GROUP	MODEL
Safety Recall Campaign	2020-2024MY Telluride (ON)
NUMBER	DATE
SC316 (Rev 1, 8/01/2024)	July 2024

FRONT POWER SEAT CONTROL SWITCH REPAIR/REPLACEMENT (SC316)

This bulletin has been revised to include additional information. New/revised sections of this bulletin are indicated by a black bar in the margin area.

4-Screw Type

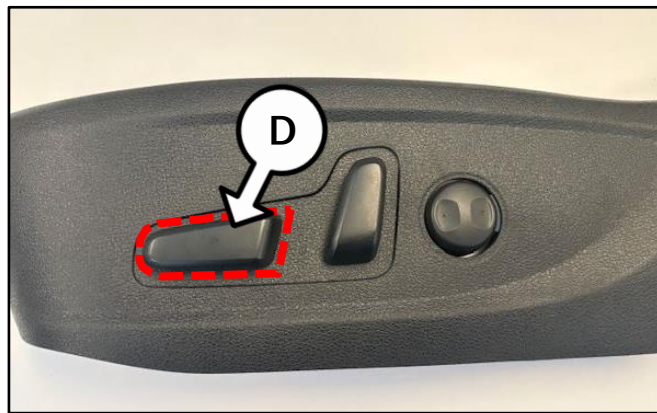
- 7a. Install a 30mm long strip of Tesa® Tape in the upper left corner of the 4-Screw Type bracket only, as shown.

- 7b. Install the provided bracket, as shown.

Tightening torque for screws:
88.5 lb.in (10.0 N.m)

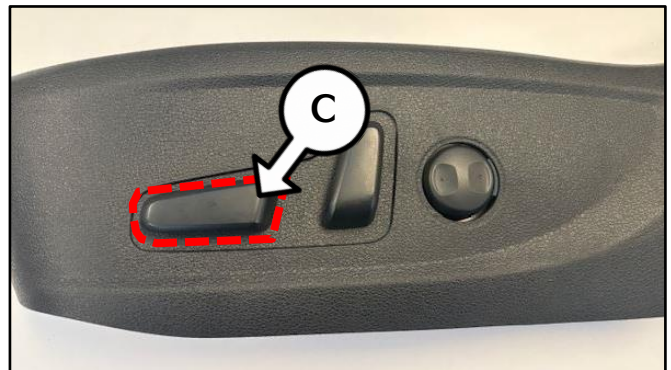
The NEW switch does NOT require the bracket be installed.

Tightening torque for screws:
88.5 lb.in (10.0 N.m)
